Subject: Response to Request for Additional Information – WCAP-15872-NP, Rev. 0, “Use of Alternate Decay Heat Removal in Mode 6 Refueling.”

**WCAP-15872, "Use of Alternate Decay Heat
Removal in Mode 6 Refueling"**

WCAP-15872-NP, R00
"Use of Alternate Decay Heat Removal in Mode 6 Refueling"
Request for Additional Information
dated October 2, 2003

Figure A-3
Sample Cases: Average Refueling Pool Temperature

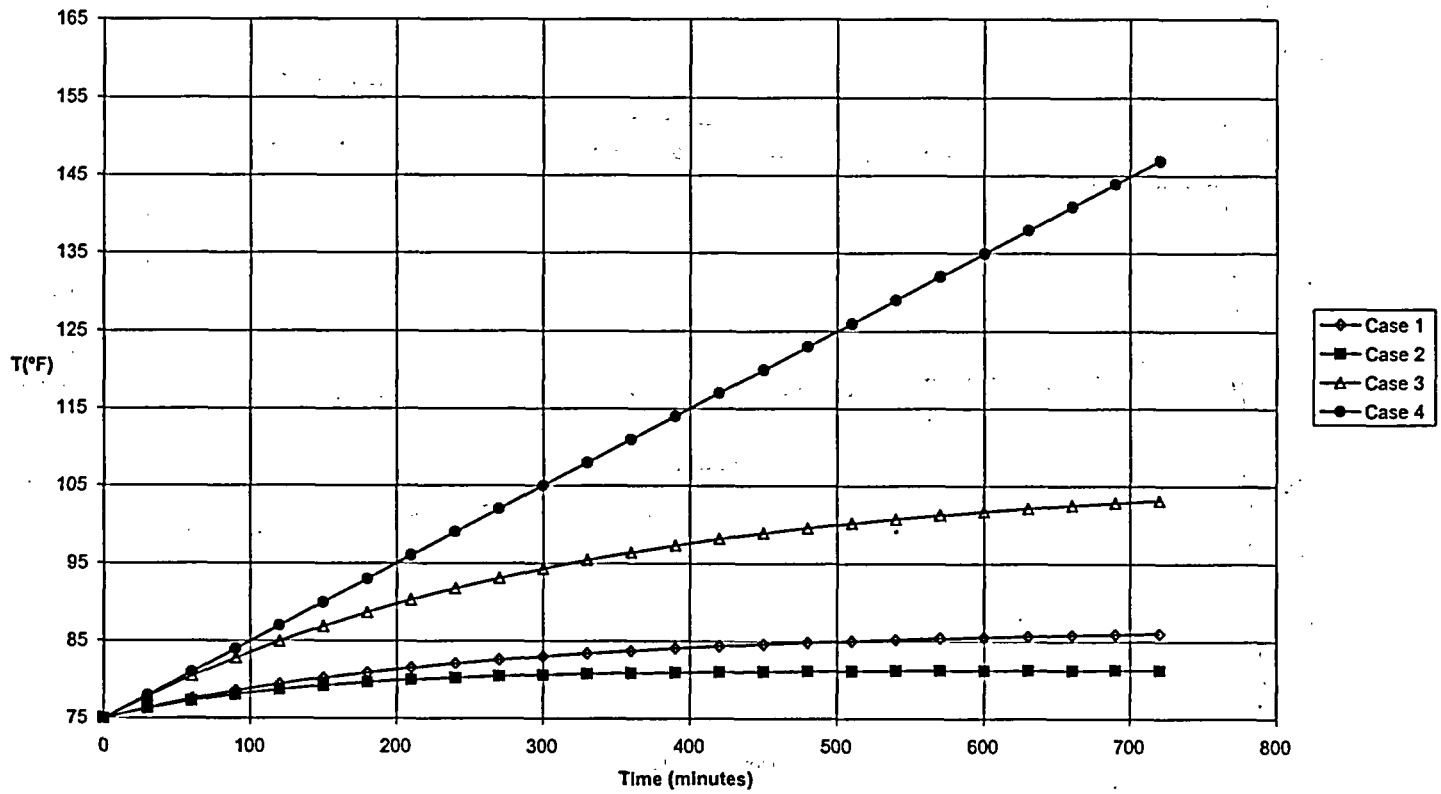
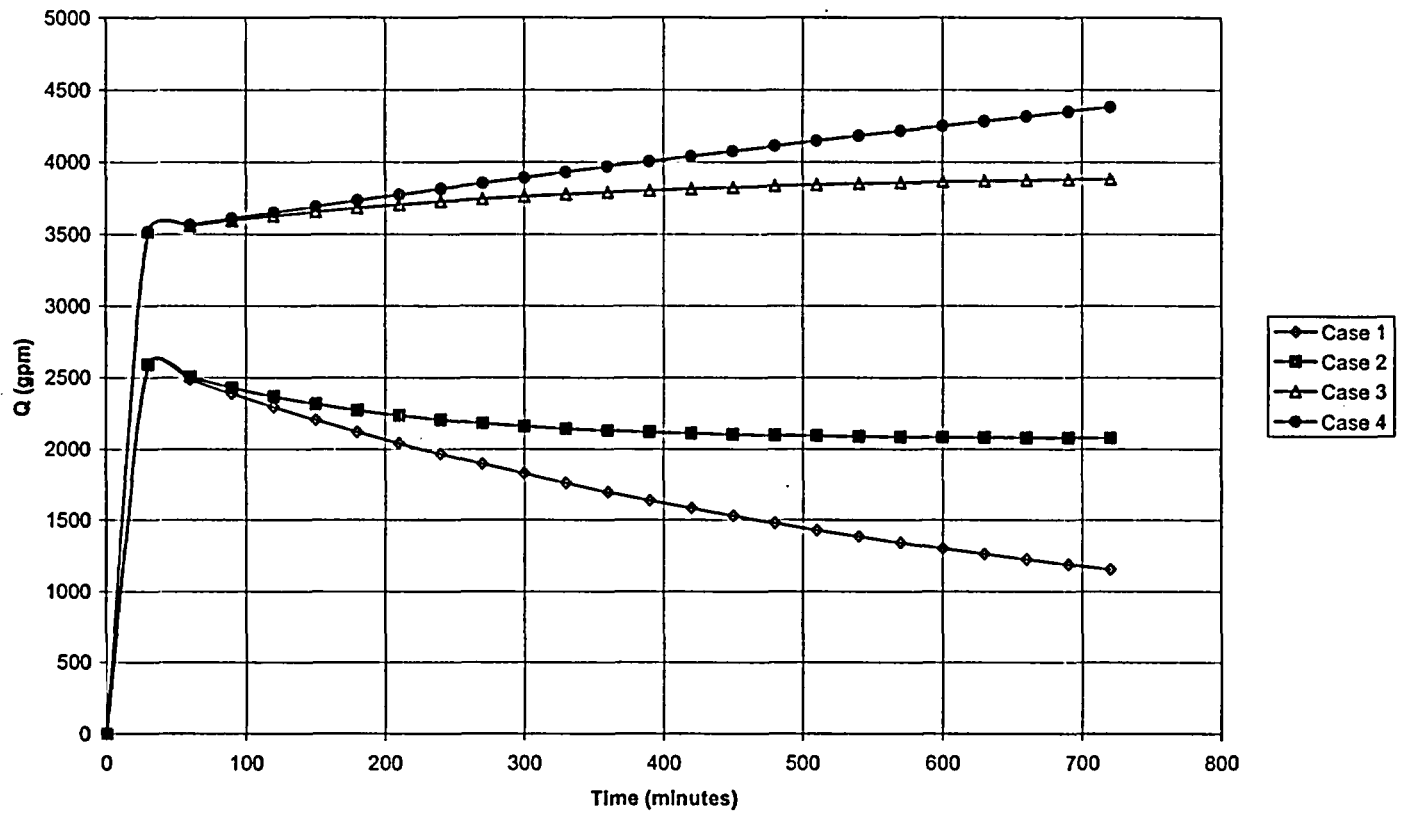
RAI A7. Please show the derivation of the values of ϵ_{mix} and ϵ_{bypass} used in the results shown in Figs. A-3 and A-4 for Case 2 and Case 3.

The mixing and bypass coefficients are defined in Appendix A and derived as shown in Appendix D. However, for the results shown in Figure A-3 and Figure A-4, these coefficients were assumed well mixed, i.e., $\epsilon_{mix} = 1.0$ and all alternate heat removal flow fully mixed with the natural convection flow from the core, $\epsilon_{bypass} = 0.0$. In Appendix A, Case 2 represents full SDC flow plus alternate cooling flow; Case 3 represents only alternate cooling flow. (Note that sample Cases 1 – 4 in Appendix A are not the same as test Cases 1 – 4 listed in Appendices B, C and D.)

Figure B-4
CCNPP Unit 2 Outage Tests: Spent Fuel Pool Flow Rate and Temperature versus Time

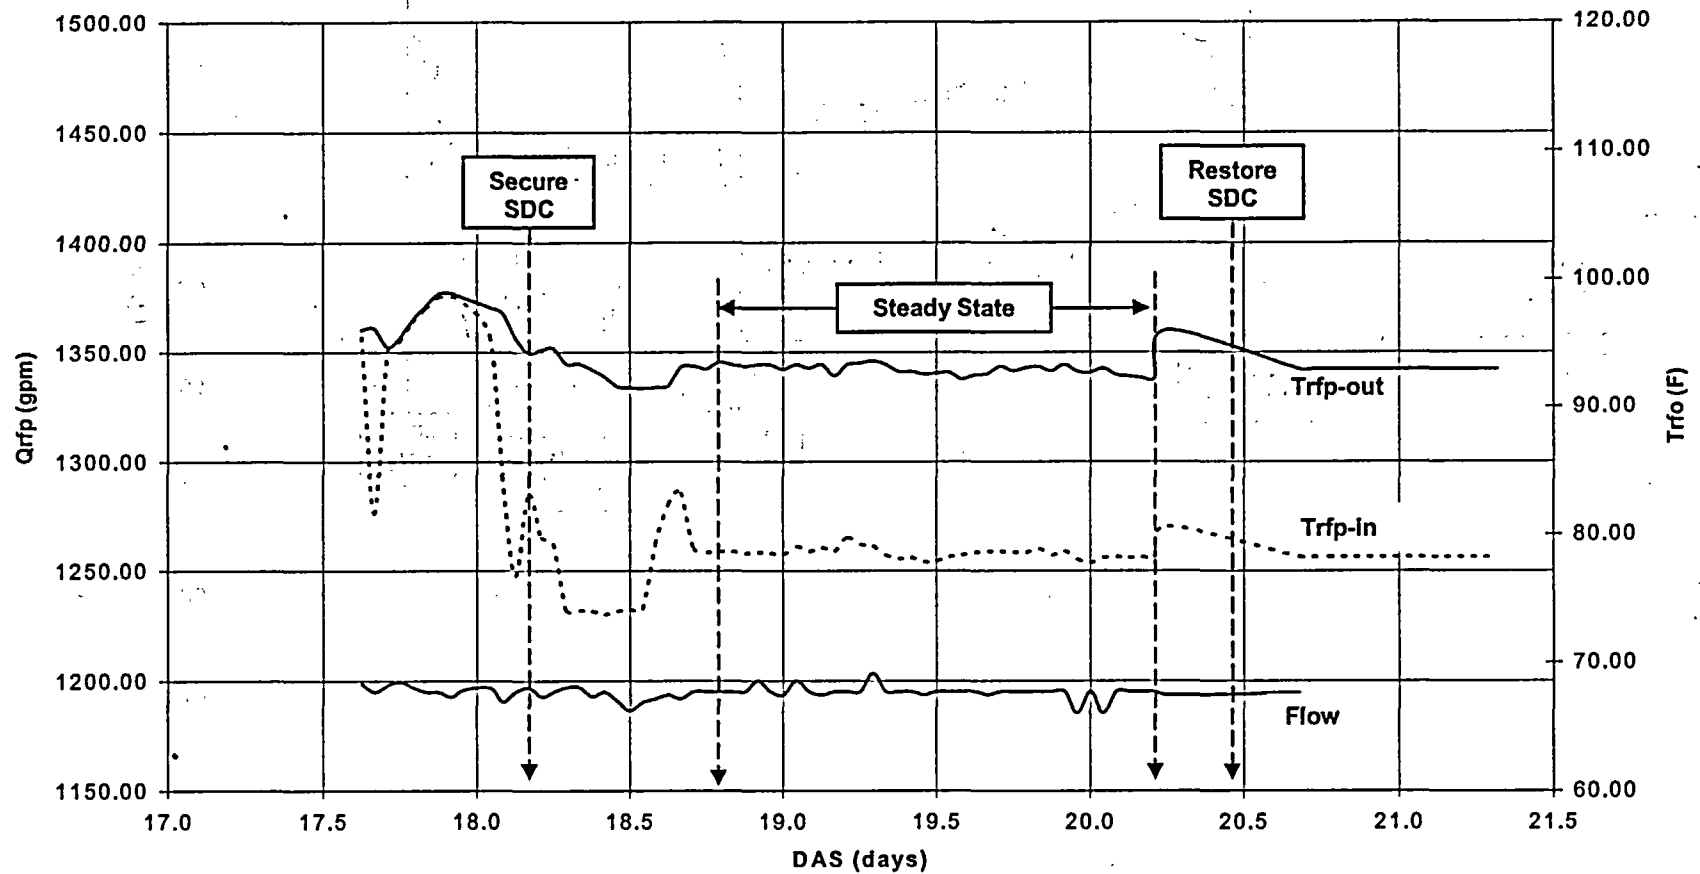
RAI B4. Table B-2, B-3 and B-4 report time in days, hours and minutes respectively. Also, the figures use two different time scales. Please resubmit for review all tables and figures based on one time scale. (If there is a specific reason, such as clarifying a relationship, state so.)

Time scales in Tables B-2, B-3 and B-4 are expressed in terms of clock time, total elapsed time and time in days after shutdown in order to expediently illustrate a particular result. For example, an event having a duration of minutes is not easily illustrated if expressed using a time-scale of days. Total elapsed time is used to compare measured and predicted values, while days after shutdown is the important parameter for tracking the point at which changes such as initiation and securing of shutdown cooling, head removal, initiation and securing of alternate cooling, and return to shutdown cooling occur.

Figure D-2
Flow Paths for Bypass Flow

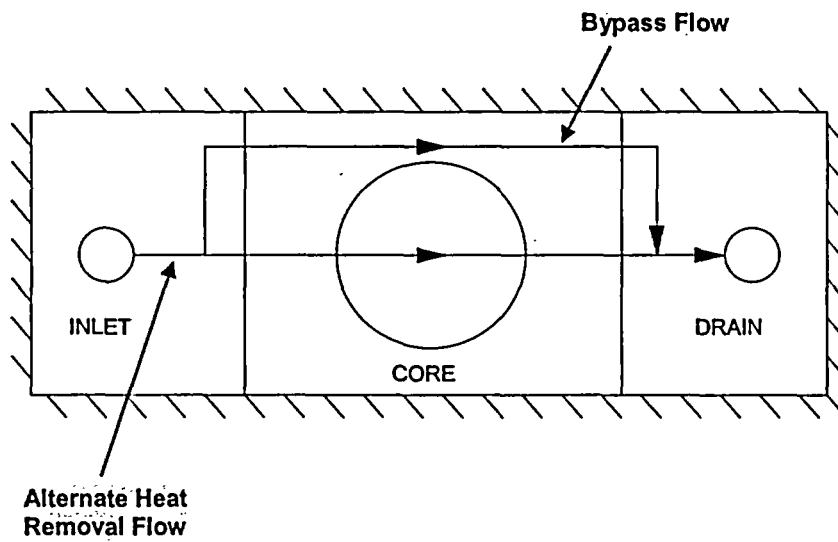
RAI D1. Please describe the simplified one-dimensional computational model and its relation to the two-dimensional computational fluid dynamics model. How does it differ from the one-dimensional model discussed in Appendix A? When you say "computational fluid dynamics model" (without the adjective "one-dimensional") in D.3, what are you referring to - A 3D model? Figures D-3 through D-6 give 2D results. So, how are you treating the situation in Figure D-2?

The mixing and bypass coefficients reflect three-dimensional effects into the one-dimensional analysis, shown in Appendix A, for natural circulation flow rates and refueling pool temperatures. The mixing coefficient is a measure of the uniformity of the refueling pool temperature, while the bypass coefficient, represented schematically in Figure D-2, is an indicator of the flow rate from the alternate cooling alignment that bypasses the natural circulation plume from the core.

Predictions of refueling pool temperatures using the three-dimensional CFD model, described in Appendix C, are then used to calculate both mixing and bypass coefficients. These values are then used in the one-dimensional model. Final values are selected based on agreement between the one-dimensional predictions, the CFD analysis results, and the data.

Figure E-10
Tilt Angle as a Function of Fluid Velocity

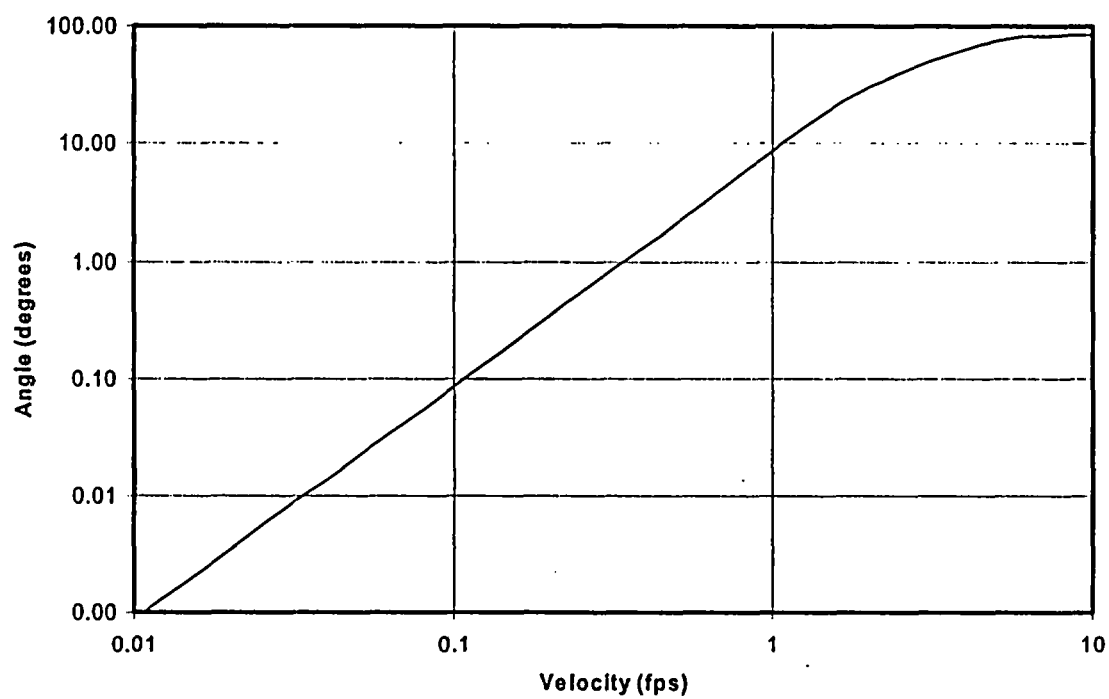
RAI E7. How do you get from a one-dimensional model the flow rate in the core for a lateral velocity of 0.22ft/sec in the refueling pool? The precision is astounding!

The velocities were taken from the CFD analysis and are representative of the magnitude of lateral velocities that could be expected. The text has been revised to state that the velocity is approximately 0.2 ft/sec.
